Access Compliance Report

Public Rights-of-Way

(Curb Ramps)

Intersection ID: 6155	Main Street: OAK_DR	Cross Street: OAKBLUFF_CR	Location: NW
ADA ID: CB9B77801FE7	Ramp Type: BlendTrans1	Initial Pass/Fail: Fail	Overall Compliance: No
Severity Score: 21.25			
Codes/Mitigation Info/Possible Solution		Field Measurements/Component Compliance

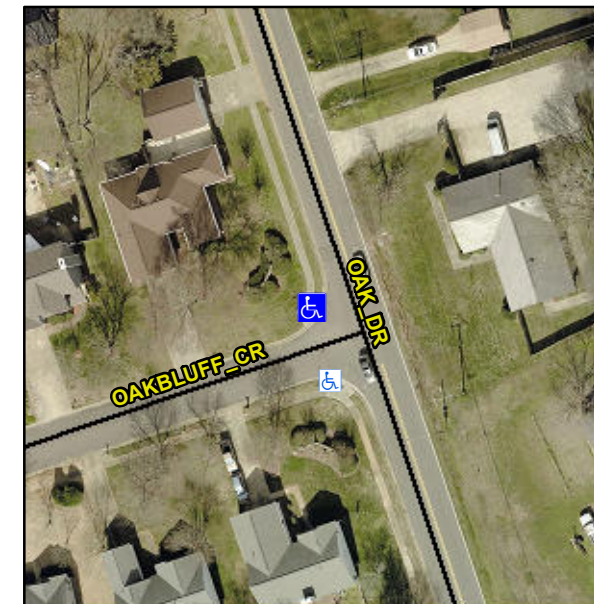
NO LT SW

Not Found, R304.5.1, R304.5.3

Compliance	Description	Data	Compliance	Description	Data
N/A	Ramp Length (in)	53.0	Yes	BlendTrans Slope (%)	4.6
No	Ramp Width (in)	46.0	No	BlendTrans XSlope (%)	5.7
N/A	Flare Type LT	N/A	N/A	Flare Type RT	N/A
N/A	Flare Slope LT (%)	N/A	N/A	Flare Slope RT (%)	N/A
N/A	Flare Traversable LT?	N/A	N/A	Flare Traversable RT?	N/A
N/A	Landing Length (in)	N/A	N/A	DWS Provided?	N/A
N/A	Landing Width (in)	N/A	N/A	DWS Contrast?	N/A
N/A	Landing Slope (%)	N/A	N/A	DWS Length (in)	N/A
N/A	Landing X Slope (%)	N/A	N/A	DWS Full Width?	N/A
N/A	Landing Curb? (Y/N)	N/A	N/A	DWS Offset (in)	N/A
N/A	Shared Landing?	N/A			
N/A	Gutter Ponding?	N/A	N/A	Gutter Slope (%)	N/A
N/A	Gutter Lip Ht (in)	N/A	N/A	Gutter X Slope (%)	N/A
N/A	Painted X Walk1?	No	N/A	Painted X Walk2?	N/A
	X Walk 1 Direction	To SE		X Walk 2 Direction	N/A
	X Walk 1 Width (in)	N/A		X Walk 2 Width (in)	N/A
	X Walk 1 Slope (%)	3.4		X Walk 2 Slope (%)	N/A
	X Walk 1 X Slope (%)	4.9		X Walk 2 X Slope (%)	N/A

N/A	Ramp inside XWalk1?	N/A	N/A	Ramp inside XWalk2?	N/A
	Road Slope (%)	4.9		Clear Space?	N/A
	Road X Slope (%)	3.4	N/A	Clear Space to XWalk (in)	N/A
N/A	Any Obstructions?	N/A	N/A	Storm Grate/Utility Hazard?	N/A
	Obstruction Type			Storm Grate/Utility Type	
		N/A			N/A
			Yes	Surface Condition? (G/P)	Good
			No	Curb Slope (%)	23.7

Remove & Replace Curb Ramp With Two New Directional Ramps or Equivalent.
